Commentary on “Modified MMF (Morgan–Morgan–Finney) model for evaluating effects of crops and vegetation cover on soil erosion” by Morgan and Duzant (2008)

Abstract: The Morgan–Morgan–Finney (MMF) model is a widely used semi-physically based soil erosion model which has been tested and validated in various land use types and climatic regions. The latest version of the model, the modified MMF model, improved its conceptual physical representations through several modifications of the original model. However, the modified MMF model has three problematic parts to be corrected: 1) the effective rainfall equation, 2) the interflow equation, and 3) the improperly normalized C-factor of the transport capacity equation. In this commentary, we identify and correct the problematic parts of the modified MMF model, which should result in more accurate estimations of runoff and soil erosion rates.

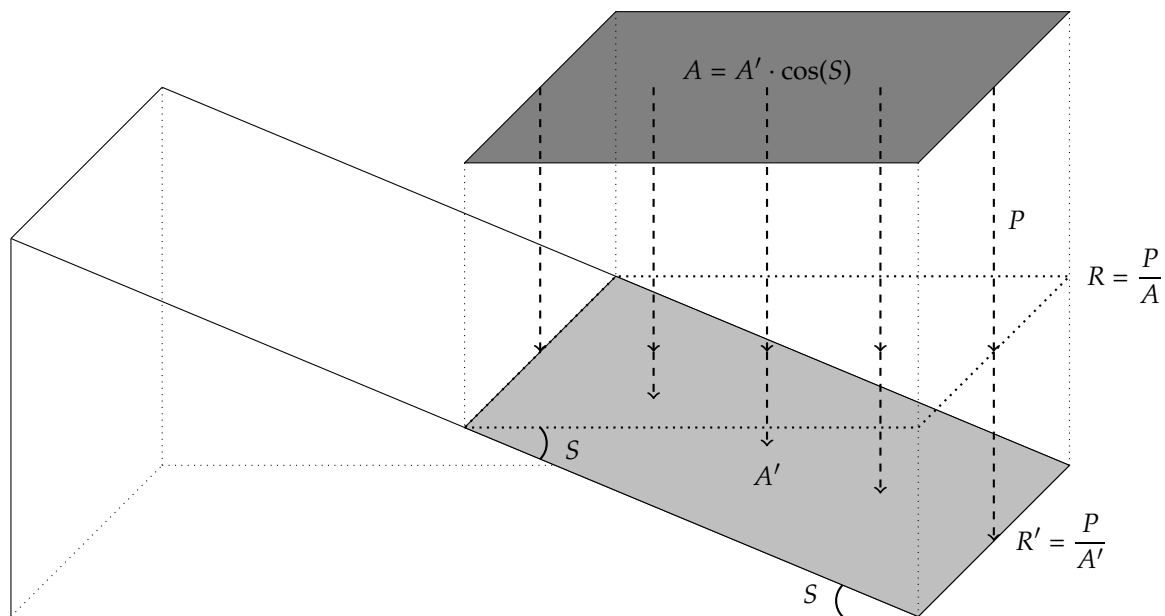
However, we argue that in order to calculate effective rainfall correctly, $\cos(S)$ should be used as a sloping adjustment factor rather than $\frac{1}{\cos(S)}$ as described in Sharon [21] and Tani [22]. We demonstrate our claims through a mathematical proof and Figure 1.

Thus, the slope adjustment factor should be $\cos(S)$ rather than $\frac{1}{\cos(S)}$ in order to calculate effective rainfall (Rf) considering the slope.

$$Rf_{\text{corrected}} = R' \cdot (1 - PI) = R \cdot (1 - PI) \cdot \cos(S) \quad (6)$$

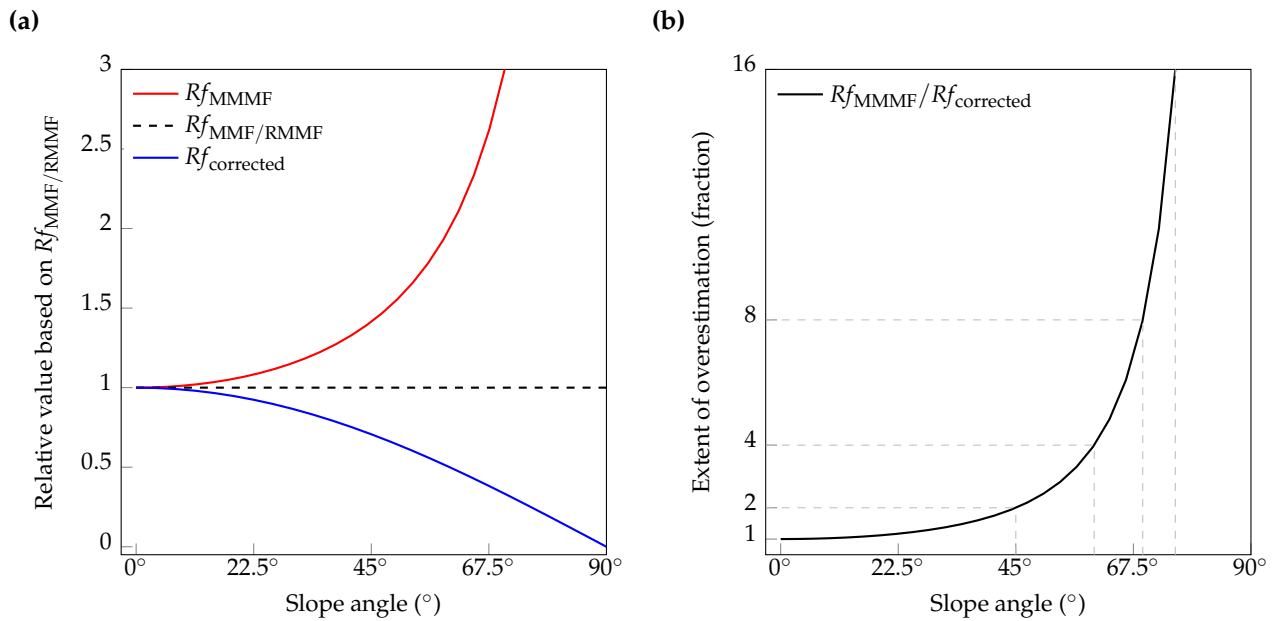
Due to the problematic slope adjustment factor of the effective rainfall by Morgan and Duzant (2008), the model overestimates the effective rainfall when the slope of an element increases as shown in Figure 2.

In the case of Setiawan [19], the MMMF model overestimated effective rainfall by at least 136% of the corrected value at areas with a slope greater than 31.0°, which account for most of the research site. If the MMMF model have applied to the site of Tesfahunegn *et al.* [17], the DMMF model would

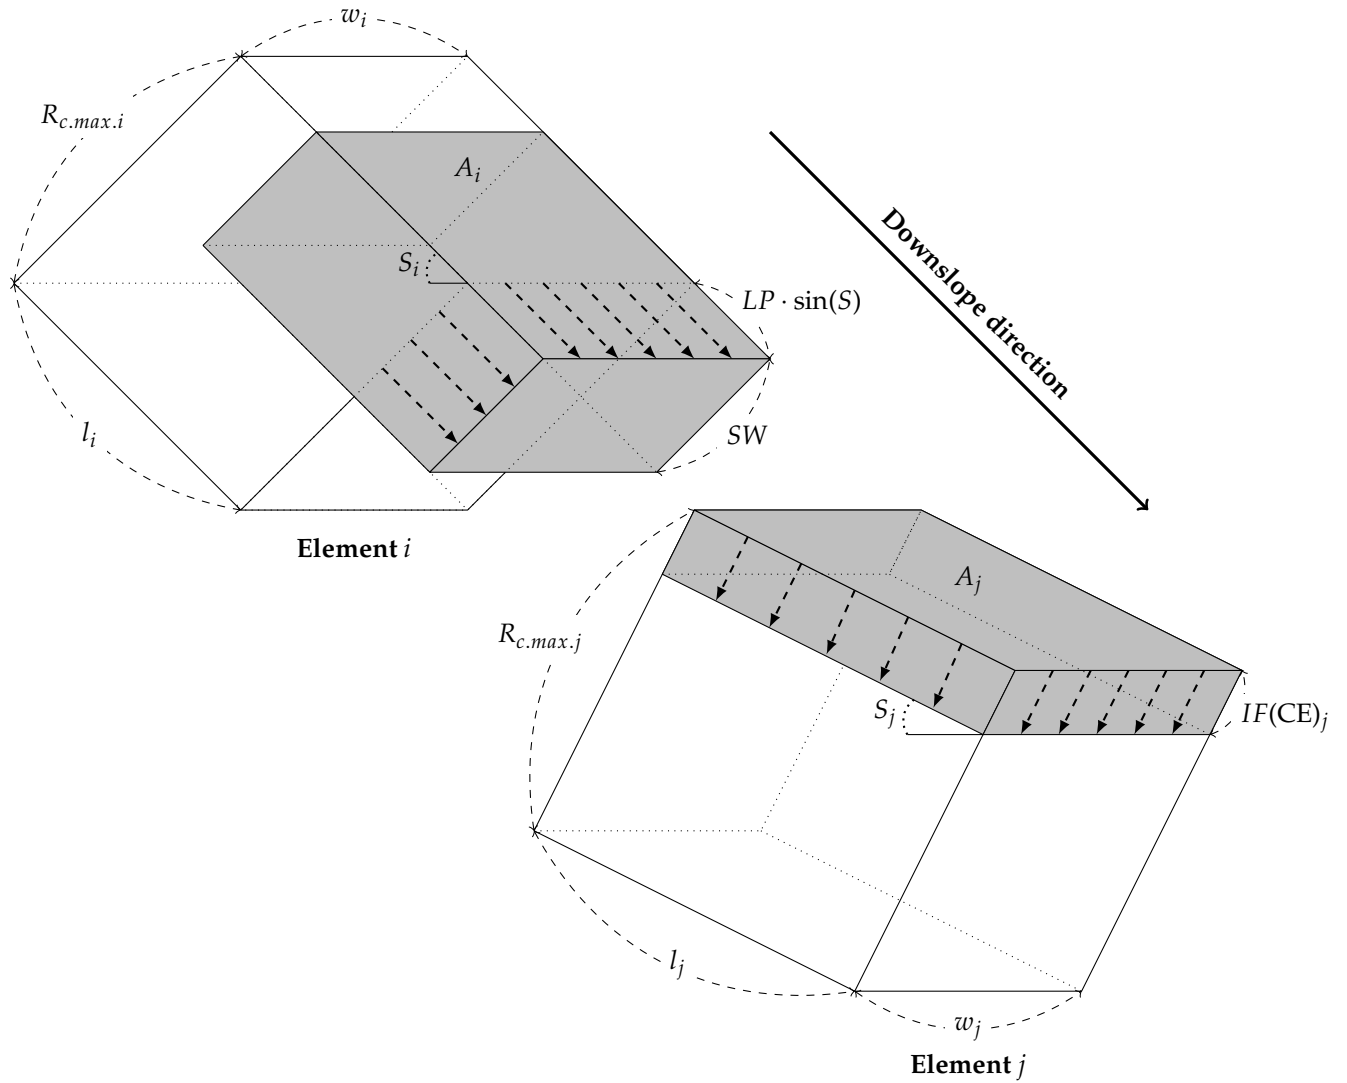
In the modified MMF model, the unit of IF_{MMMF} is defined as volume per unit area ($\text{L m}^{-2} = \text{mm}$) similar to other hydrological quantities in the model (i.e., R , R_f , R_c , E , and Q). However, the unit of interflow in equation (7), which is depth multiplied by velocity (or length for daily time steps), contradicts the definition of IF_{MMMF} as depth (mm) in the model.

We argue that the interflow equation is improperly formulated and that the IF_{MMMF} has the wrong unit. Let's consider the interflow generated from an element i in Figure 3.

Therefore, the additional term of $\frac{1}{l_i}$ is required for the interflow equation of Morgan and Duzant [9]. Furthermore, with this term, $IF_{corrected}$ has the right unit of depth (mm). The dependence of interflow on slope length is obvious as in the lateral flow equation of the widely used SWAT model (in equation 2:3.5.9 by Neitsch *et al.* [23]) since the SWAT model also uses water volume per unit area. We also derived the same formula of $IF_{corrected}$ using the theoretically well-established Darcy's law in the supplementary material of this article.

There is another problem in the interflow equation even if $IF_{corrected}$ is used instead of IF_{MMMMF} . As shown in Figure 3, the generated interflow from the element i flows into the element j . Because the total volume of interflow (V_{IF}) is the same for both elements, interflow into the element j ($IF(CE)_j$) should be:

$$IF_{corrected} = \left(\frac{R - E - Q}{365} \right) \cdot (LP \cdot \sin(S_i)) \cdot \frac{1}{l_i} = \frac{IF_{MMMMF}}{l_i} \quad (11)$$

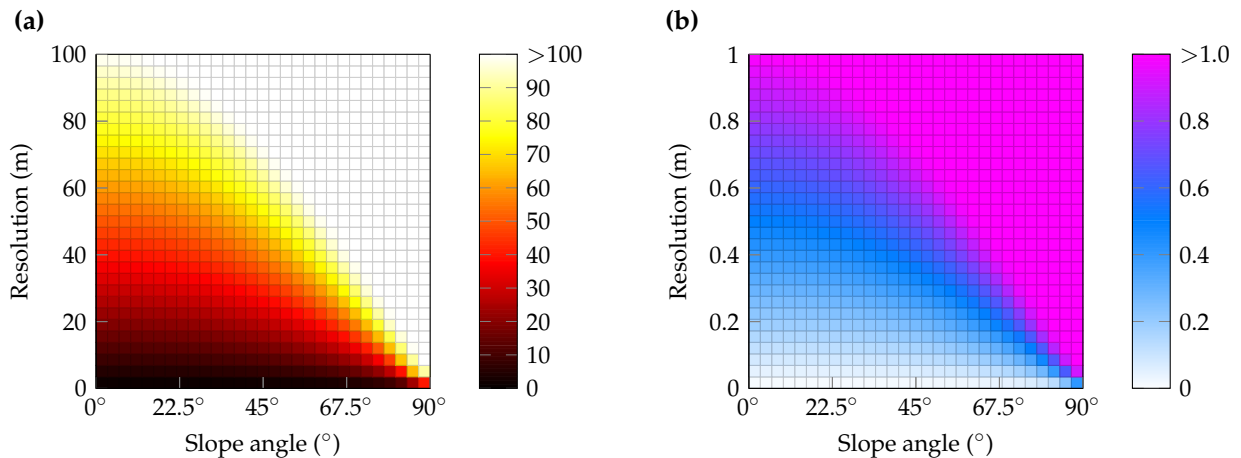
Due to the incorrect formula in the interflow equation of Morgan and Duzant [9], the MMMF model overestimates interflow when the slope length of an element increases. However, the model underestimates interflow if the slope length of an element is less than one meter. Figure 4 shows the extent of the overestimation in the case of the MMMF model is applied to raster maps such as a digital elevation model (DEM). For a DEM with a certain resolution (res ; m), the width (w) and the length (l) of each element are equal to res and $\frac{res}{\cos(S)}$. Therefore, the extent of overestimation of the interflow is dependent on the slope of an element and the resolution of the DEM.

In the case of Setiawan [19], who applied the MMMF model using a DEM with a 0.05 m resolution for a maximum slope of 41°, the MMMF model estimated at most only 7% of the corrected interflow. In the case of Lilhare *et al.* [10], who applied the MMMF model using a DEM with a 90 m resolution, the extent of overestimation is over 90 times compared to the corrected interflow. Due to the discrepancy between the generated and the transferred interflow, the model overestimates the interflow from contributing elements to a receiving element when the receiving element is steeper than contributing elements as shown in Figure 5. Also, the model underestimates the interflow from contributing elements, when contributing elements are steeper than the receiving element. The extent of the discrepancy increases with the increase in slope differences between contributing and receiving elements.

Figure 5. Extent of the discrepancy between the generated interflow from a contributing element and the transferred interflow to a receiving element.

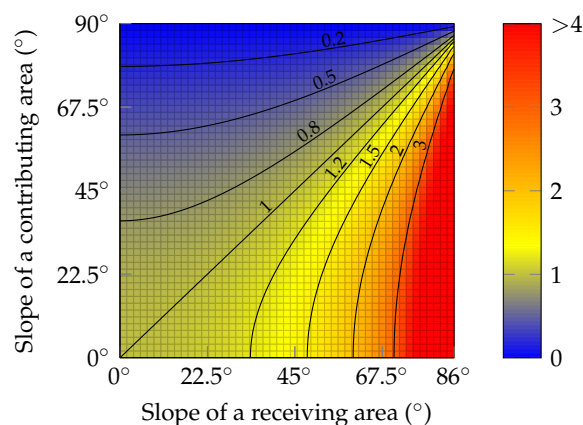
Because errors in the calculation of interflow are positively correlated with the size, the slope, and the rate of change in the slope of elements, the model is not suitable for steep mountainous terrain with complex topography. Furthermore, the interflow affects the quantity of surface runoff by affecting the amount of the soil moisture storage (R_c) as shown in eq. (10) from Morgan and Duzant [9].

Figure S1. Conceptual representation of soil water in an element. A , w , l , and S are the area (m^2), the width (m), the slope length (m), and the slope angle ($^\circ$) of the element. SW (mm) is the daily mean soil water over a year and the σ_a (m^2) is the cross-sectional area of SW .

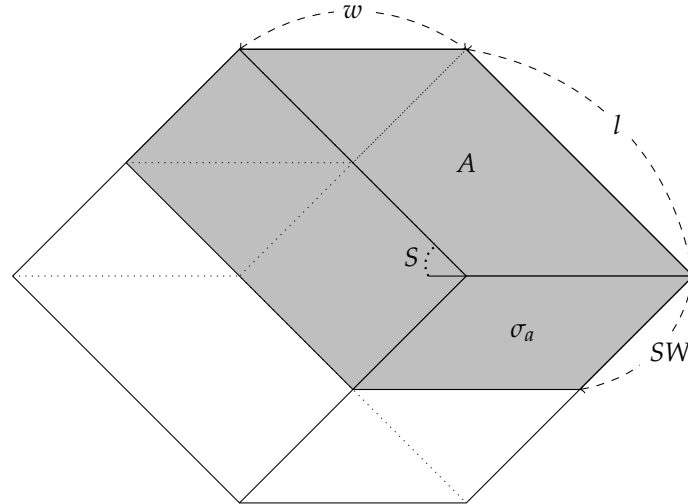
Assume that there is the amount of soil water equivalent to the daily mean soil water over a year (SW ; mm) in an element and only soil water exerts a force on the element for the interflow process (see Figure S1).

$$IF_{corrected} = 1000 \cdot \frac{V_{SW.out}}{A} = \frac{LP \cdot SW \cdot w \cdot \sin(S)}{l} \quad (S7)$$
